Access Compliance Report

Public Rights-of-Way

(Curb Ramps)

Main Street: LOS_ALAMITOS_BLVDCross Street: ROSSMOOR_WAYLocation: NE

ADA ID: RPRK211217125324Ramp Type:Type 1 - Perpendicular Diagonal Initial Pass/Fail: PassOverall Compliance: NoSeverity Score: 6

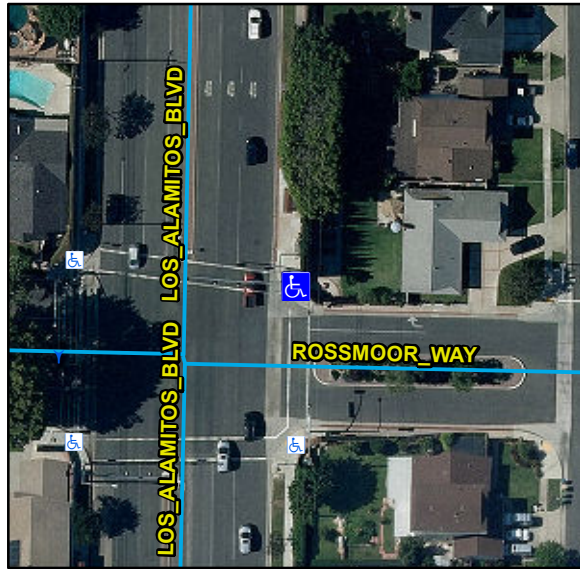
Remove & Replace Curb Ramp With Two New Directional Ramps or Equivalent.

R304.2.2, R304.2.1, STD 1115
